TE Connectivity

Product Change Notification: E-19-007117

DEUTSCH DT Series 2pin-12pin Plug and Receptacle E-seal Grommet Color Change

12P Before and After

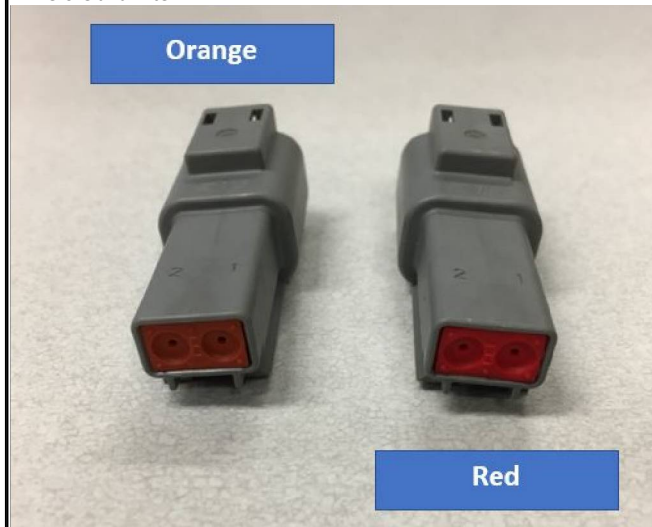
The Industrial and Commercial Transportation (ICT) business unit of TE Connectivity (TEC) is making a change to the E-seal grommet color to burnt red for the part number(s) listed below. These PNs are TE proprietary designs, therefore considered catalog/general market product. PPAP and/or sample requests must be submitted within 14 days of PCN submission via ict-ppap-request@te.com or ePPAP system. Submission will not occur without request. If PPAP requested, disposition response is required within 14 days of submit date or it will be considered approved. The product drawings are affected. Also, 114-151009 DT application specification has been revised.

Grommet Brfore and After

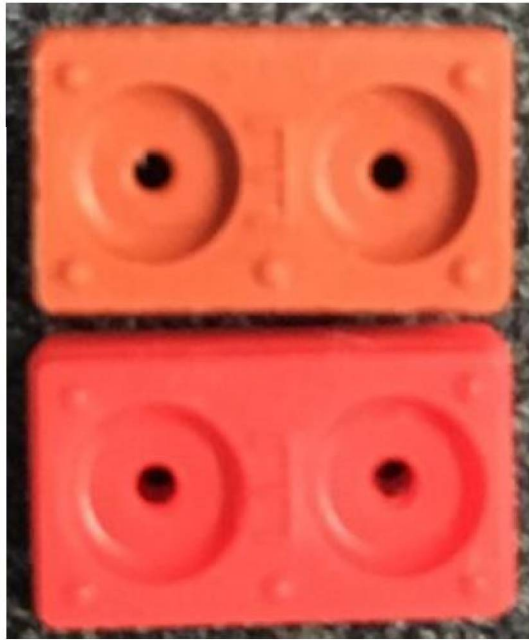
Orange (BEFORE)

Red (AFTER)
